**CITY OF JOHANNESBURG IMPACT ASSESSMENT AND COMPLIANCE MONITORING**

**ADDENDUM 1 | RESPONSE TO CITY OF JOHANNESBURG IMPACT ASSESSMENT AND COMPLIANCE MONITORING COMMENTS DATED 12 OCTOBER 2020**

Steyn City Properties (Pty) Ltd. plans to develop Riverside View Ext 84 on portions 124 and 185 of the farm Diepsloot 388 JR. The proposed zoning of the development will be *Special for: Place of Instructions, Residential buildings and Offices, including ancillary uses such as restaurants and shops* and aims to provide a school, offices and residential buildings. Private Open space will also be incorporated into the development which form parts of the Steyn City Parkland Residence which has been designed to be a modern, mixed land use and mixed income development.

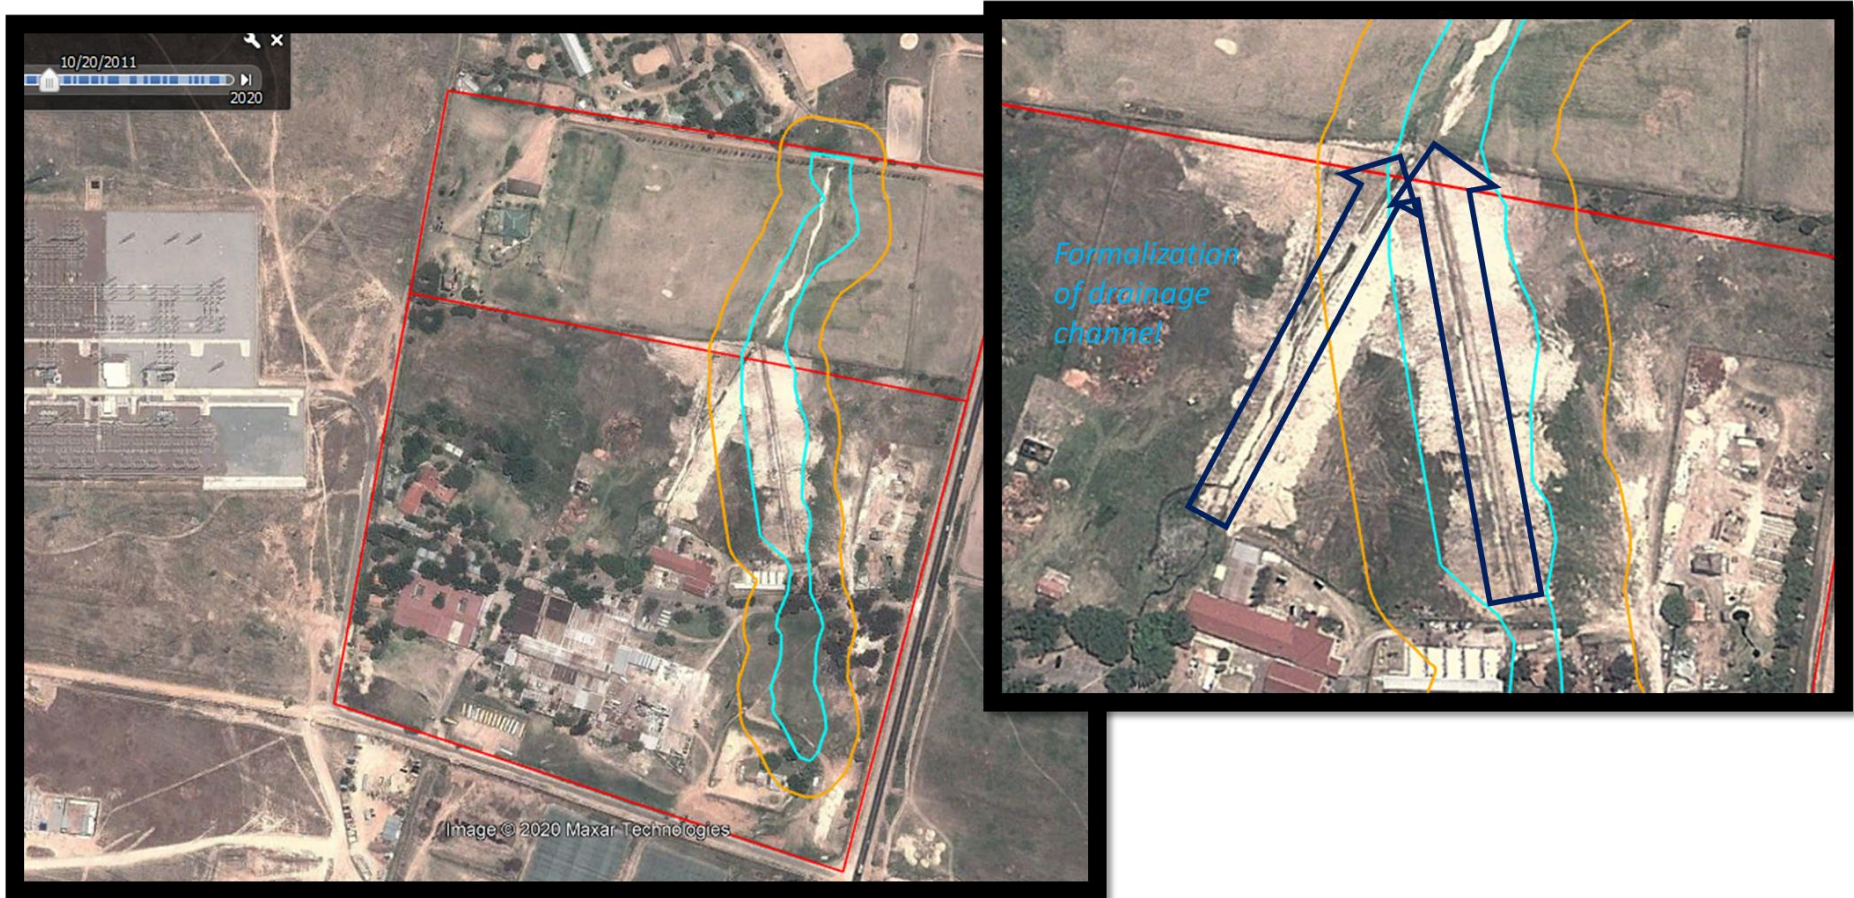
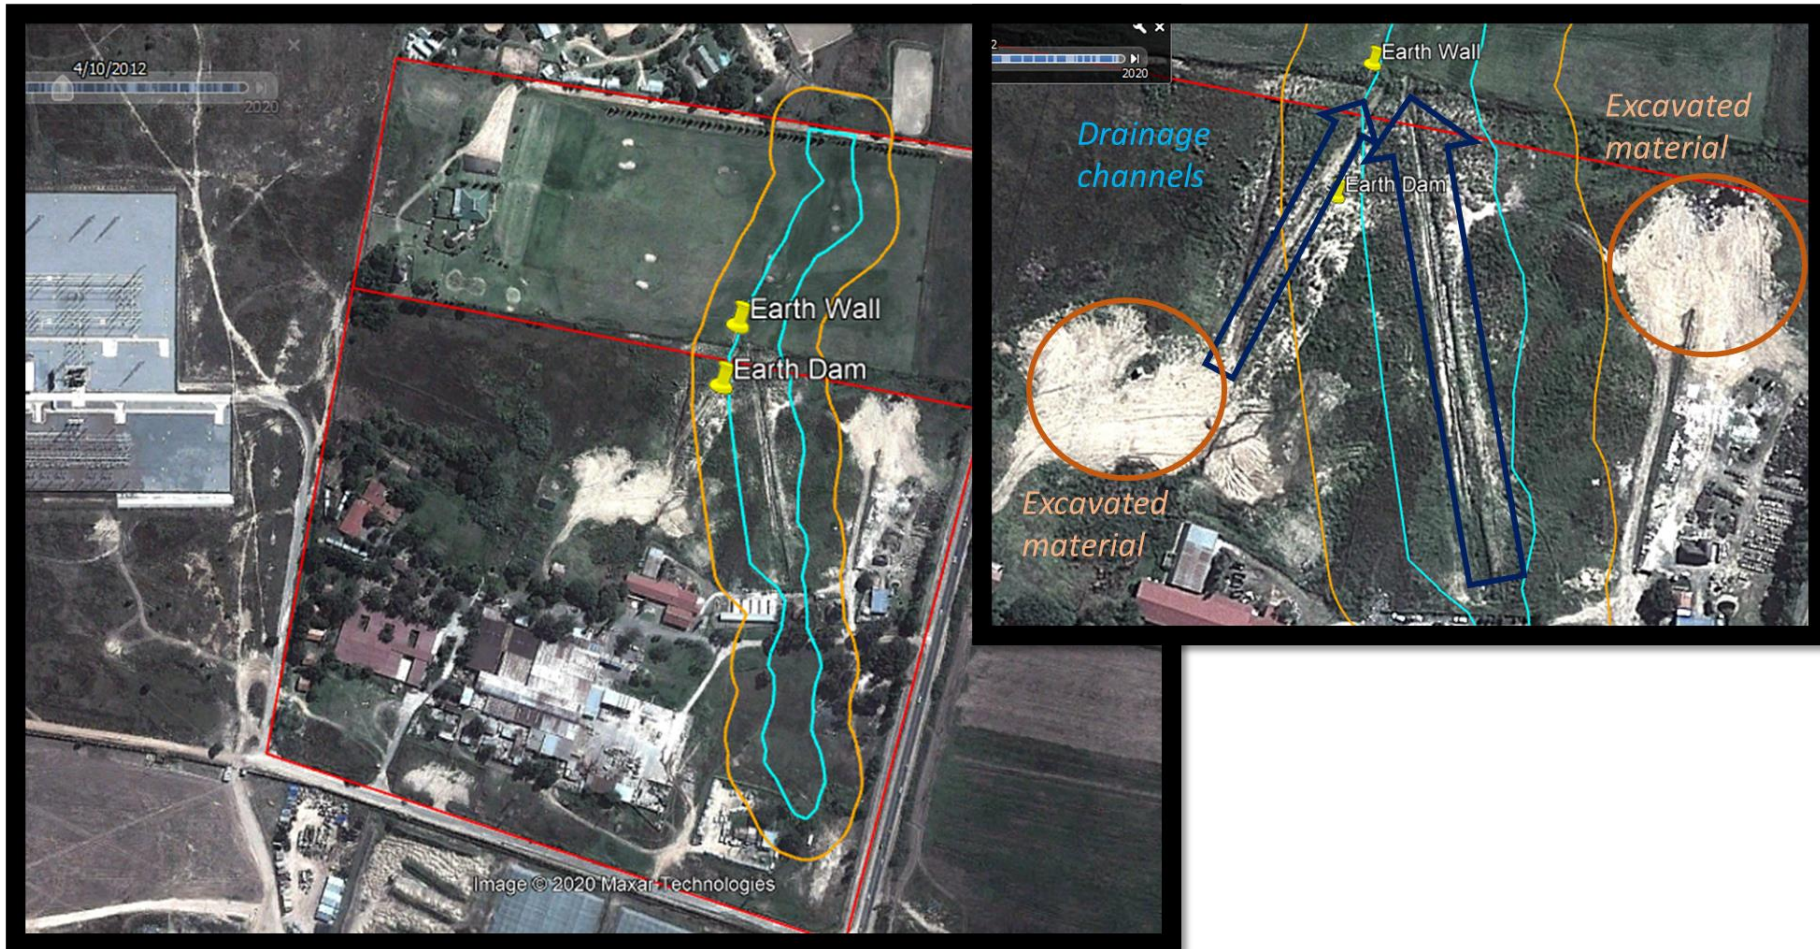
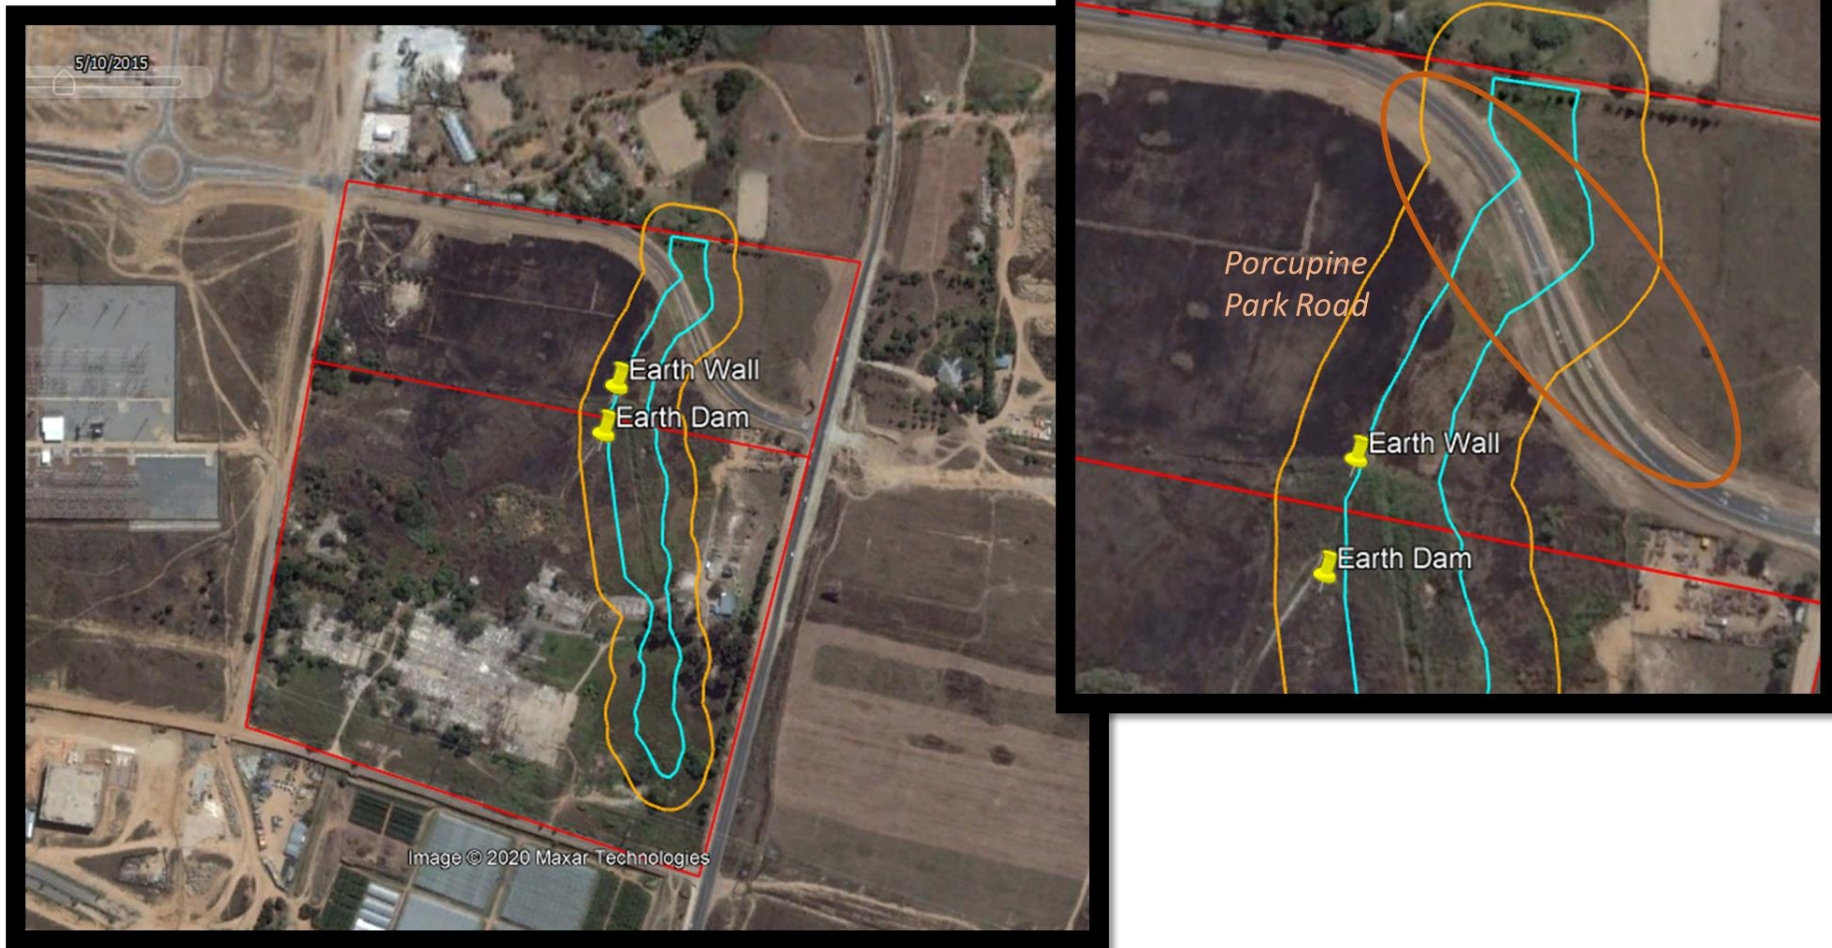
- *"Biodiversity Baseline and Impact Assessment:*
  - *In terms of the report, wet areas were also identified within the recovering grassland habitat. It is however presumed that the source of the water in these areas is from an artificial source. An investigation must be done in the final EIR on this unnamed artificial source. The findings of the Geotechnical report must be taken into consideration and the investigation must include the relationship between the seepage areas and the high biodiversity area.*

- *Wetland Assessment:*
  - *The wetland study appears to disregard the large seepage wetlands associated with the main valley bottom wetland and dismisses these. Given that the details of where verification was undertaken and the results of augur points are not provided, it is not clear how the conclusions that these seepage areas are artificially driven are arrived at.*

- *The statement under section 9.1.1.3.2. that wet areas associated with the grasslands can be presumed to be water from an artificial source' cannot be accepted at face value and without a thorough analysis. It is even possible that there may be changes to the hydrology as a result of the disruption of flow paths which has already taken place to parts of the wetland as a result of existing development such as roads etc. which appear to have encroached into, and destroyed parts of the wetland especially in the north western section."*

From October 2011 to May 2015, a number of changes to the site took place. These occurred after the Geotechnical Reports and thus are not captured within. The exact details of the changes and why they took place is not available. However, evidence from Google Earth as well as the site visits, indicate that that formal drainage channels were put in place in the wetland.

In addition, late 2012, fill material was excavated and was used for construction/upgrades of nearby roads as well as sourcing of material for manufacturing

Furthermore, whilst the school and old buildings on Portion 185 were demolished, the platforms they were built on remain in place and thus still channel stormwater. The artificial source of water referred to by the Biodiversity and Wetland Specialists relate to this stormwater. The earth dam also occurs within the degraded grassland area identified by the specialist.

Lastly in 2015, Porcupine Park Road was constructed and crosses the wetland to the north of Portion 124.

**Figure 6, 7 and 8** below provide the Google Earth Imagery from this time.

Figure 12: Typical cross section

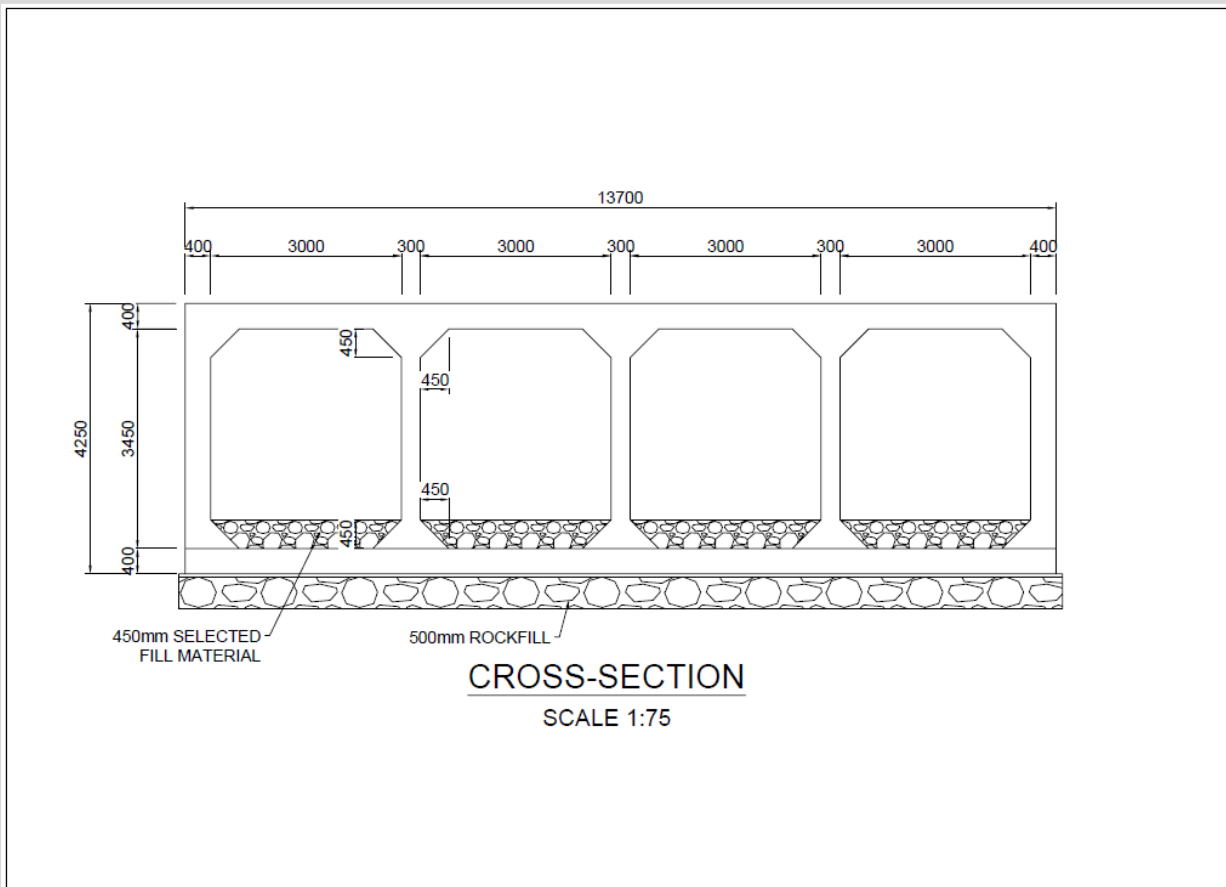
- *It is recommended that any road crossings over the wetland or riparian areas should be constructed as a span bridge with the supports located outside of the riparian zone and buffer areas, and only minimal additional support pillars permitted as required to support the span, and subject to the detailed design being approved by both JRA AND Environmental Management. The conceptual drawings appear to only consider the primary wetland and not the buffer areas.*

- *“The proposed watercourse crossing must be undertaken in such a manner that it does not impact on the hydrological process; thus, a hydrological study must be undertaken to assess the impact of the proposed crossing. A span bridge is recommended.”*

Whilst conceptually a span bridge appears to reduce the impact, this is more in relation to riparian areas. From discussions with the Wetland Specialist and Engineers, it should be noted that due to the nature of the wetland and surface flows, the pillars would need to be sunk to a level were a greater impact would be experienced. Instead, the engineers (in consultation with the specialist) have recommended a culvert which rests on a “raft” of stone which will allow for continued subsurface flow and avoid intersection with the lateral interflow. This reduces the impact to the wetland and wetland habitat. **A span bridge is therefore not recommended from a wetland perspective.**

Figure 13: Stormwater Management System showing Multiple Releases

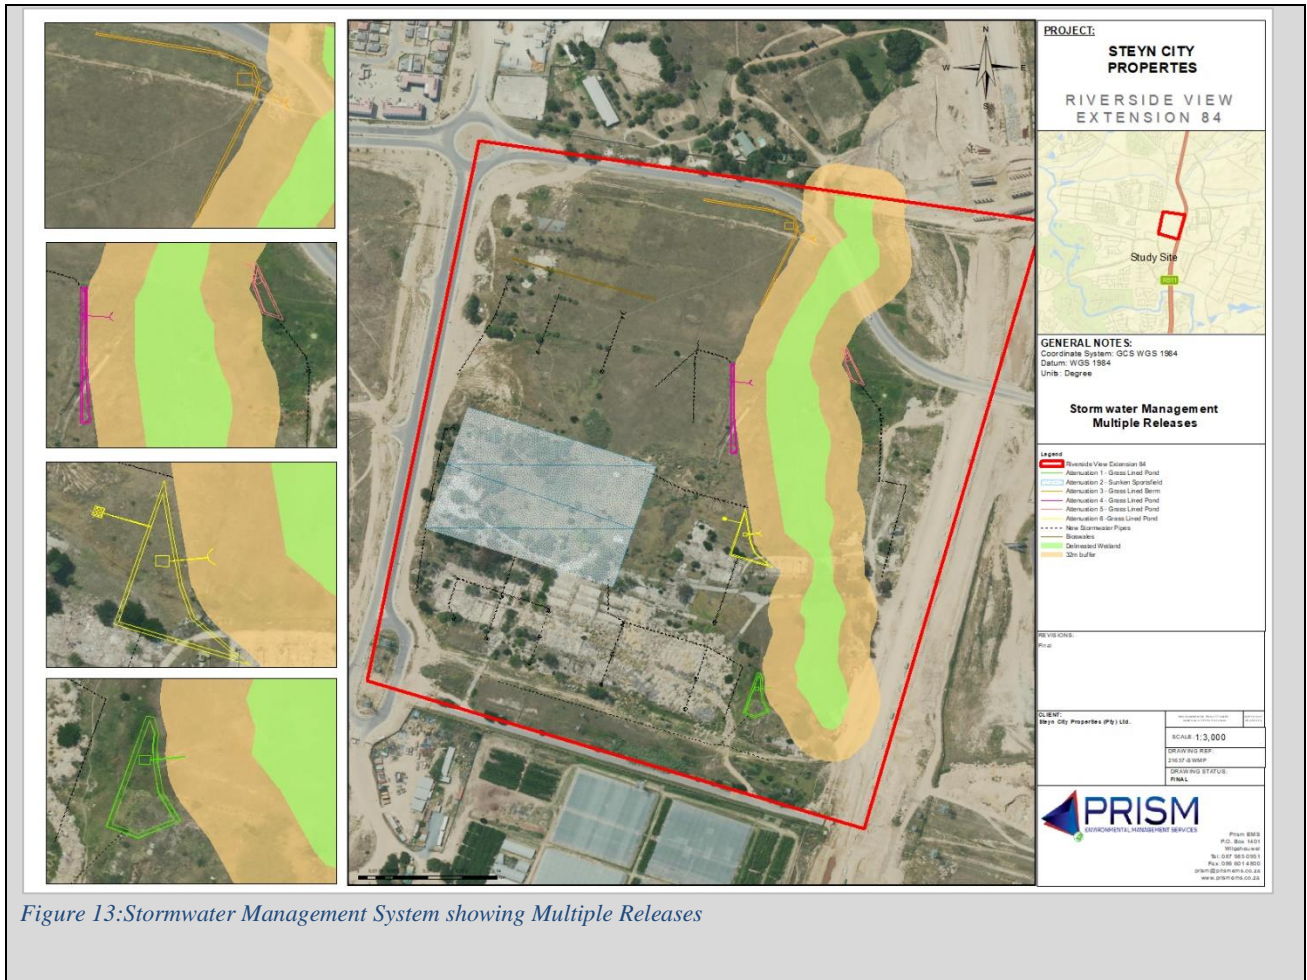
The development will need to comply with the COJ Stormwater By-Laws 2010. Particular attention is drawn to Clause 44, which requires the following:

- *Wetlands*
- *44. (1) The following requirements must, in addition to the requirements of section 38, be complied with if stormwater from any development site discharges directly, or indirectly across any intervening property, into a wetland:*
  - (a) The quantity and velocity of any stormwater discharge must be controlled and treated to the extent that such discharge attains a quality in compliance with the requirements of the National Water Act, 1998, the National Environmental Management Act, 1998 and any other applicable law;*

(b) a stormwater discharge must maintain the frequency and flow of pre-development conditions, to the extent necessary to protect the characteristic functions of the wetland;

(c) prior to discharging to a wetland, any alternative discharge location and any natural water storage infiltration opportunity outside the wetland, must be evaluated by a professional engineer and utilised for the stormwater discharge if reasonably practically possible; prior to discharging to a wetland, any alternative discharge location and any natural water storage infiltration opportunity outside the wetland, must be evaluated by a professional engineer and utilised for the stormwater discharge if reasonably practically possible;

- The design of storm water management systems should be based on the Stormwater by-law, 2010, Sustainable Urban Drainage Systems (SUDS), and Water Sensitive Urban Design approaches (WSUDS) which enhance natural drainage through permeable surfacing and integrates landscaping with storm water in line with best practice storm water management. Although the report mentions some principles which are part of the Stormwater by-law, the attenuation ponds show single points on discharge into the buffer or the 1:100 year floodline. The stormwater must be discharged in manner that maximises wetland and open space functionality and limits potential erosion. Stormwater must be managed to the satisfaction of JRA and the Environment and Infrastructure Services Department.

A stormwater management plan has been compiled by a professional engineer and provides for discharge overland within the wetland buffer. The plan utilized SUDS and all run-off from the site will be routed to the attenuation ponds of each respective catchment. Each catchment area drains into an attenuation pond whereby the run-off from the area is throttled to release into the wetland and buffer zone at the 1:5 year pre-developed flow. Energy dissipating structures will be constructed at each outlet to limit any erosion and encourage sheet flow into the wetland area.

- Grass lined attenuation ponds;
- Use of the soccer field to attenuate stormwater and allow for ground water recharge;
- Bio swales with stone filled sumps to allow for run-off retardation, encourage sheet flow and absorption into the underlying soil;
- Throttled outlet structures; and
- Energy dissipation slabs to limit erosion and encourage sheet flow at outlets.

**Figure 13** provides an overview of this plan and highlights that there are 6 separate releases along the wetland buffer at separate locations. It is not necessary to include multiple releases from each attenuation due to the fact that the site has been separated into small catchments and each catchment has its own release. It therefore has the same effect as having multiple releases from the same attenuation.
